ADDENDUM NO. 01 - BID NO.1907
SPRINKER RECREATION CENTER DEHUMIDIFICATION SYSTEM REPLACEMENT

ADDENDUM DATE: June 27, 2017

To all Bidders: Attention is called to the following items effective June 27, 2017, which shall be added to, deleted from, or revised from the CONTRACT DOCUMENTS for Pierce County Bid #1907, thereby incorporating the addendum as part of the CONTRACT DOCUMENT

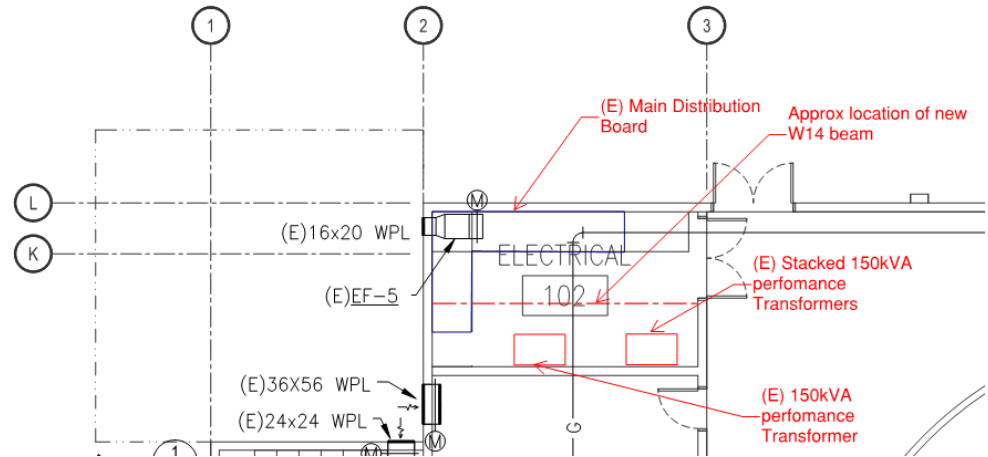
- **Demo and removal associated with the demo and removal of the existing dehumidification unit on the north side of the ice rink:** In addition to the scope of work shown in the drawings and specification, demo slab and turn fencing over to Owner. See complete requirements at Drawing revisions to Sheet M1.1 below.

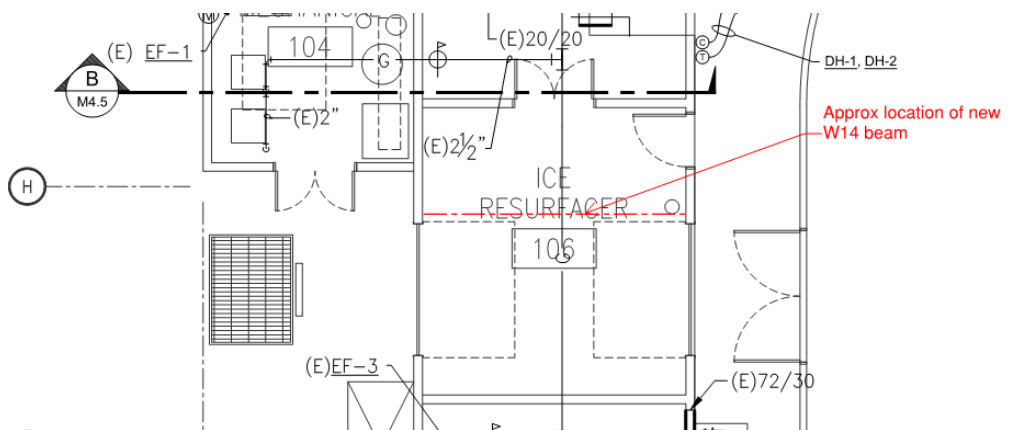
1. Sheet M0.2, Air Inlet & Outlet Schedule, **ADD** the following: “WRG; Wall Return Grille; Titus 30R; Aluminum Double Deflection Type”
2. Sheet M1.I: Near Grid 13-L, **ADD** Demolition of existing 6-inch thick concrete pad at Existing DH-3, and Salvage and remove the chain link fence and gate surrounding the unit in a manner that it can be reused by the owner. This includes the surface mount brackets for the fence posts. Store the salvaged chain link fence and gate in the contractor laydown area.
3. Sheet ME4.1, in Ice Elec 102, **ADD** locations of existing transformers, Main Distribution Board, and W14 beam as shown in the not to scale sketch below:
